**ADDENDUM # 1**

<b>Project</b>	TA Blakelock High School Renovations	<b>Project No.</b>	2215-C
<b>Location</b>	1160 Rebecca Street, Oakville, ON	<b>Date of Issue</b>	2025 04 24
<b>Owner</b>	Halton District School Board	<b>File</b>	2215/7.1.3

This Addendum forms part of the Contract Documents and amends the original Drawings and Specifications, dated 2025 04 17, and all preceding Addenda, as noted below.

**A1-2 DRAWING A100-D KEY PLAN, FLOOR PLANS - ELEVATORS - DEMO**

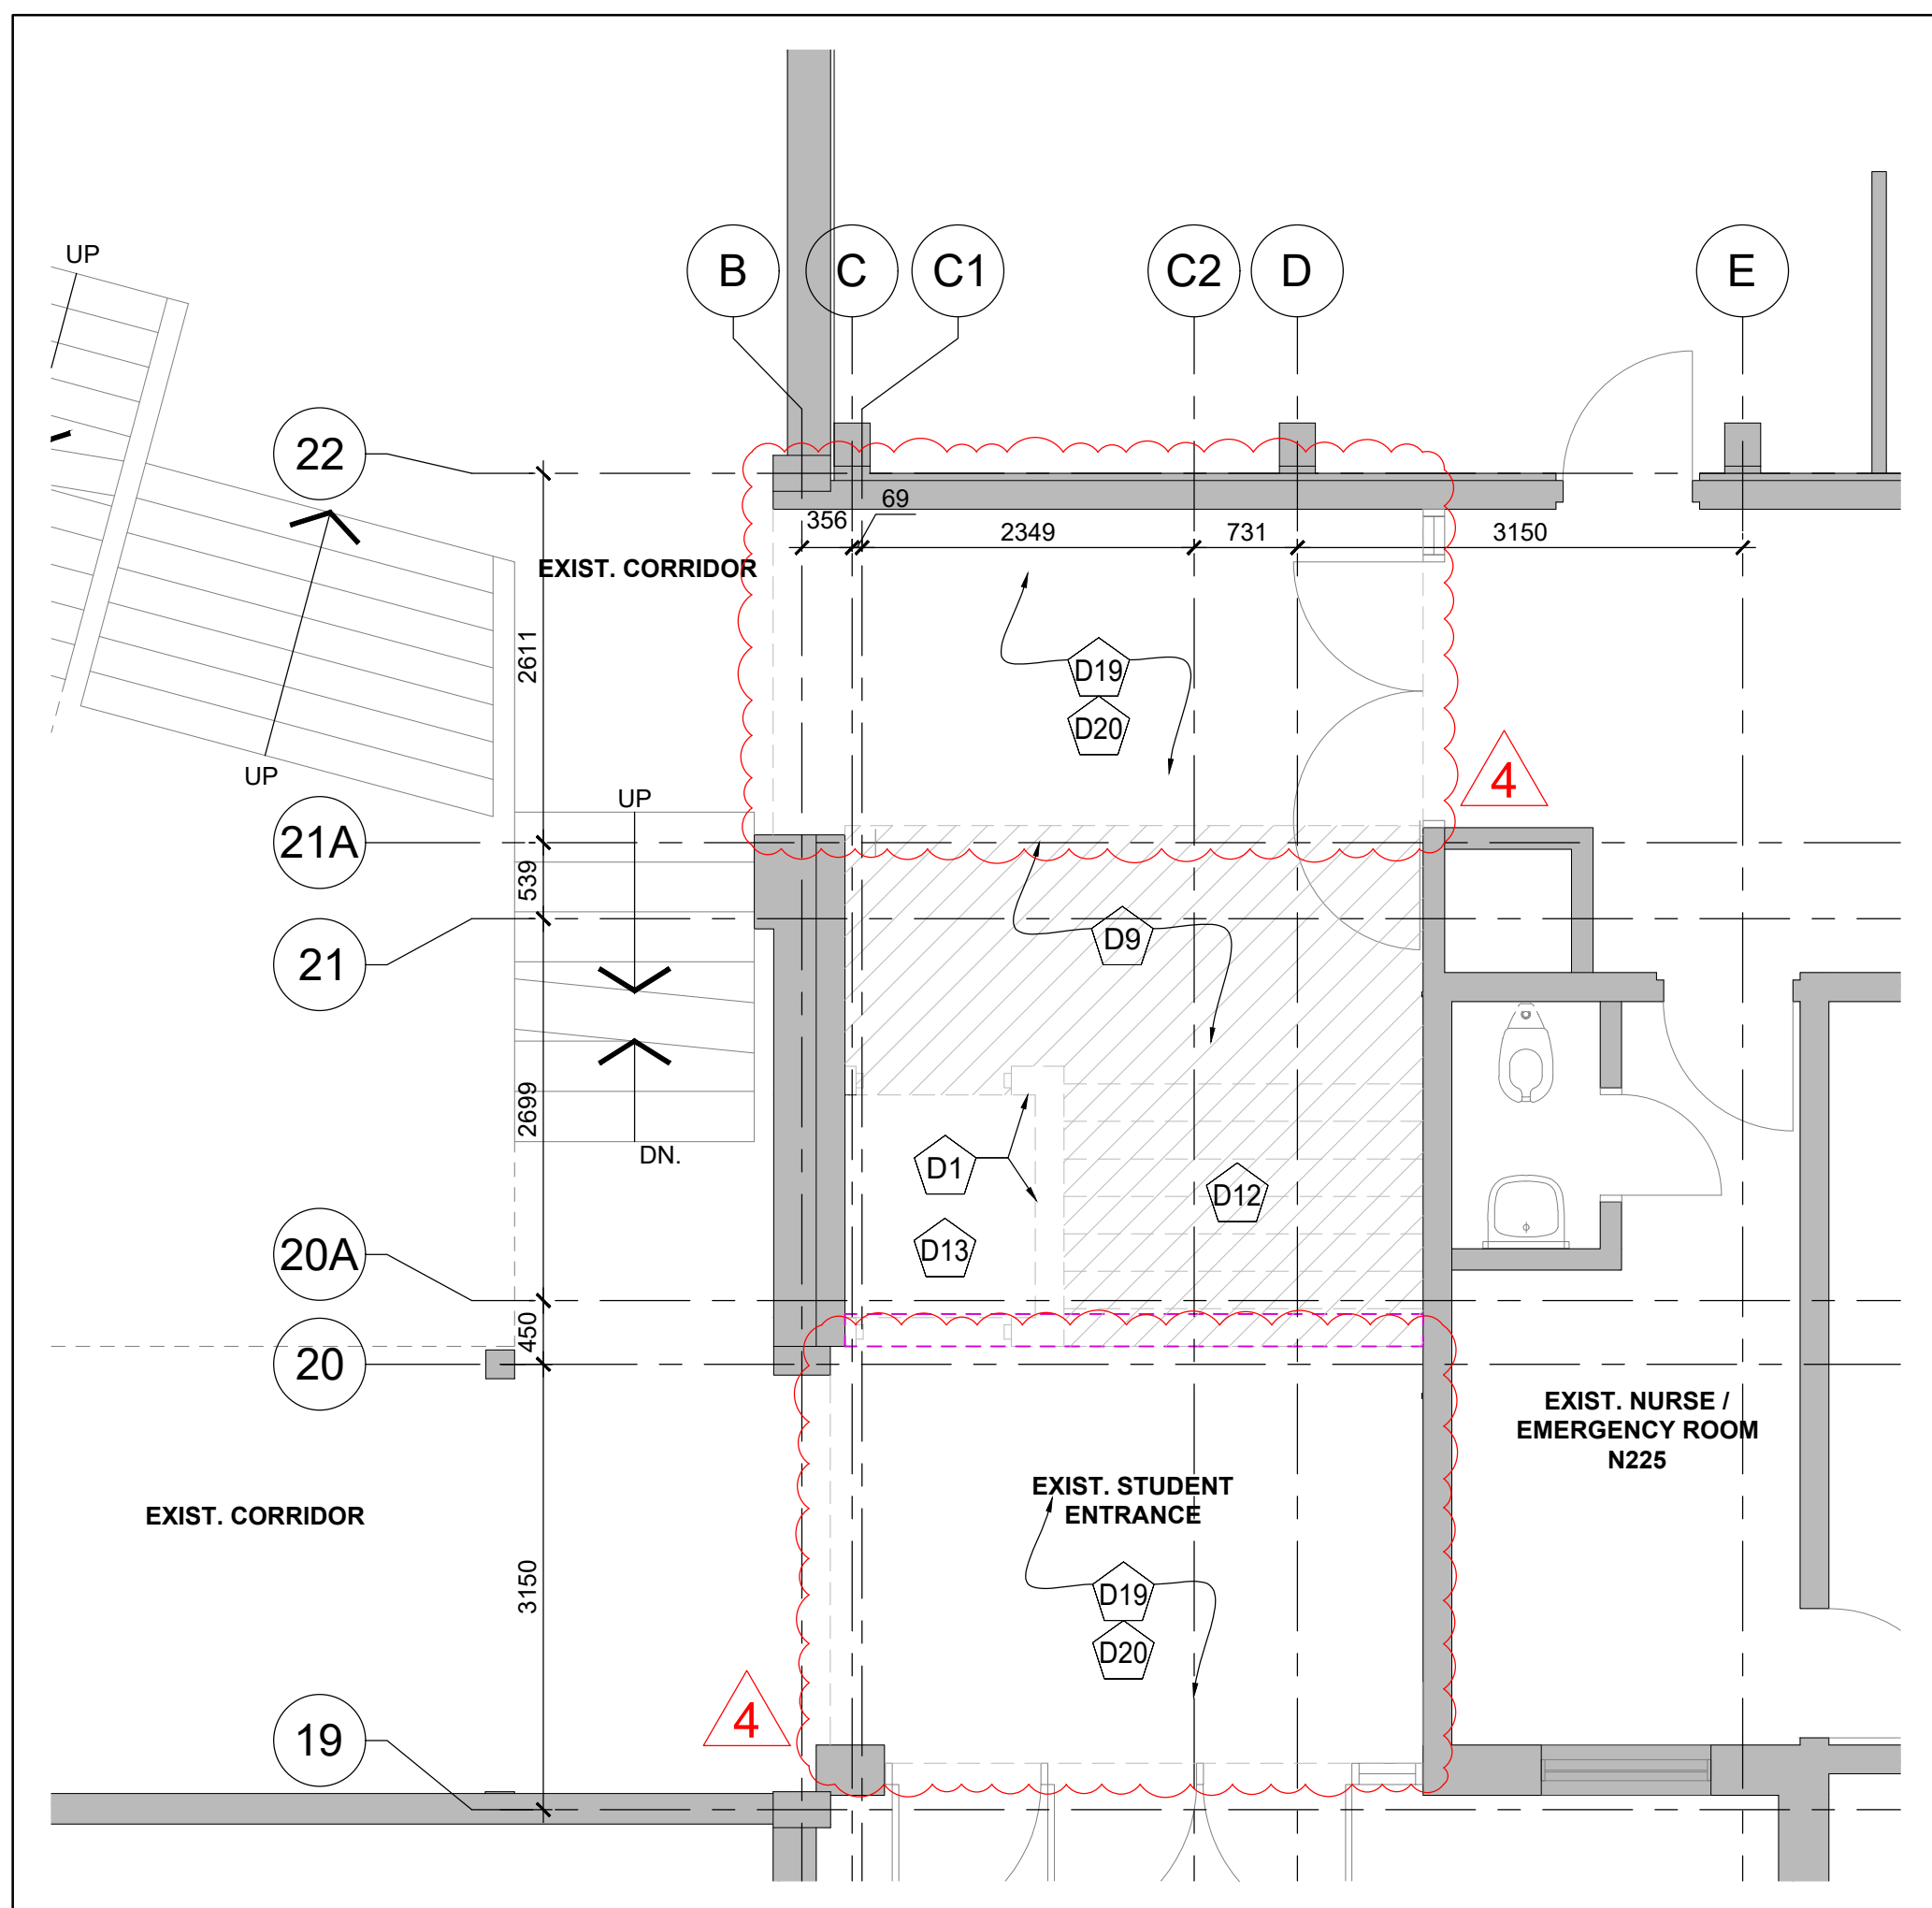
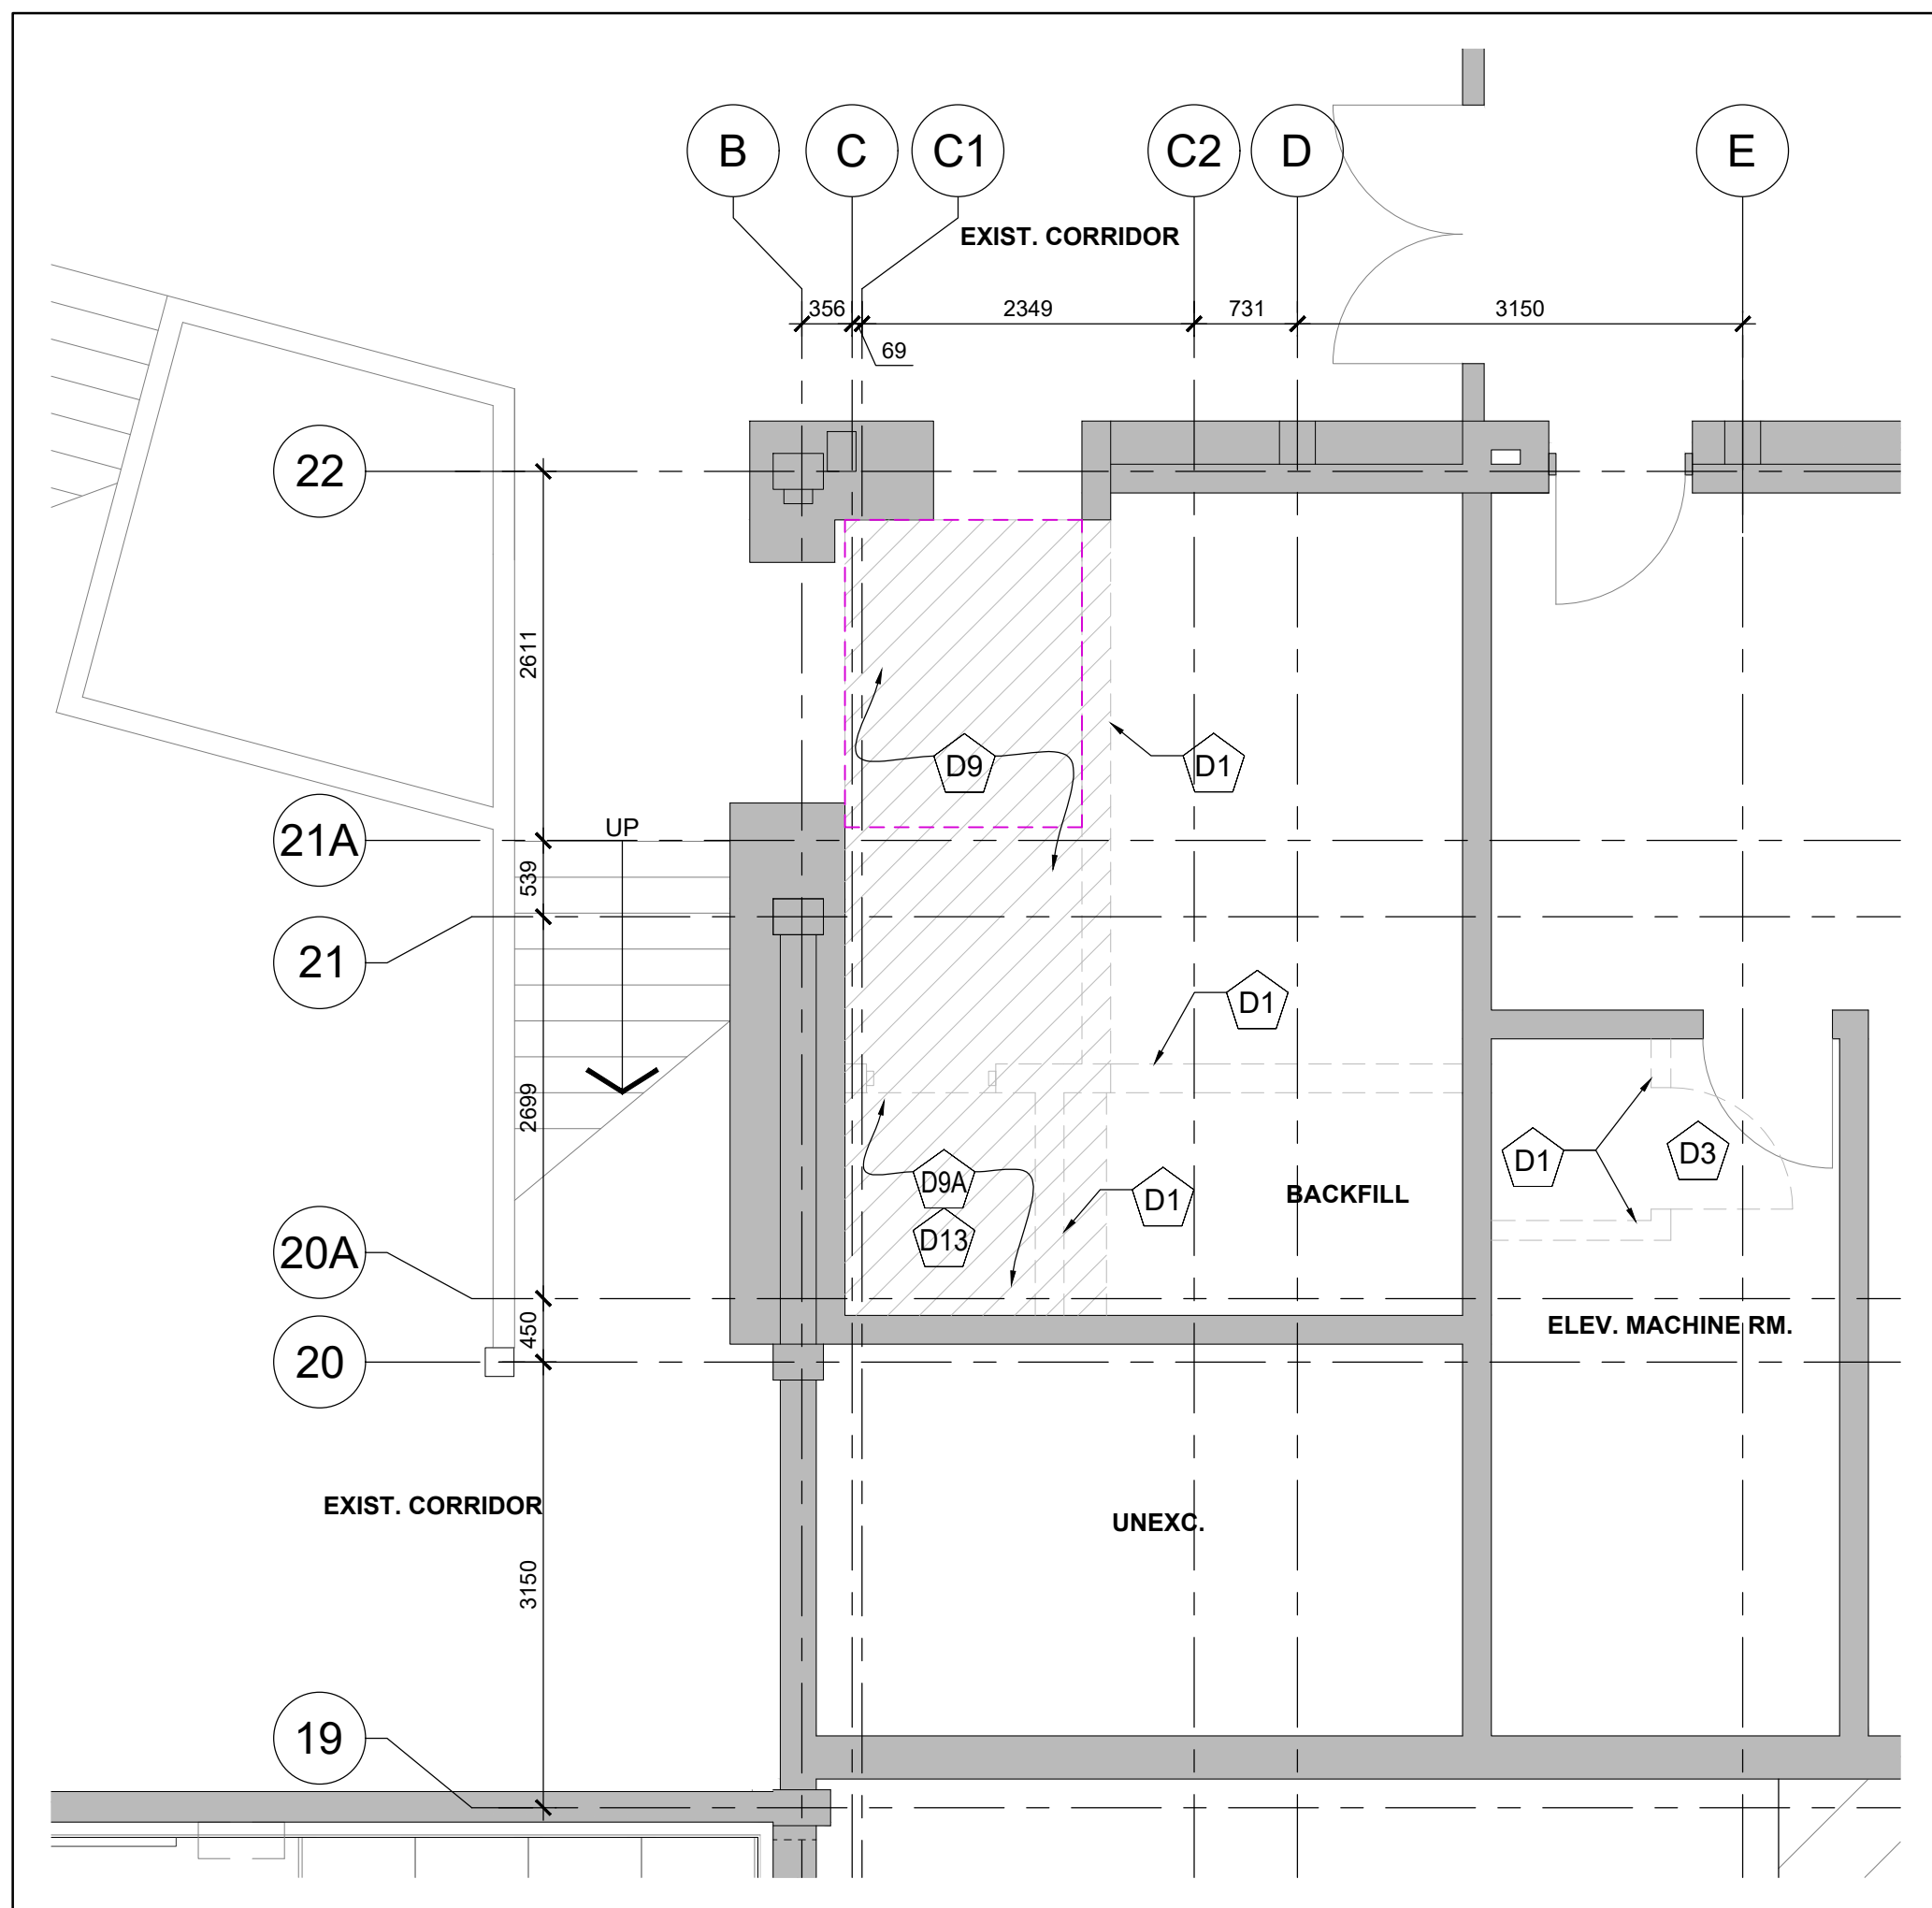
- .1 Replace drawing with the attached Revision No. 4.
- .2 Drawing reissued to clarify demolition scope and include additional Demolition Notes D15-D20.
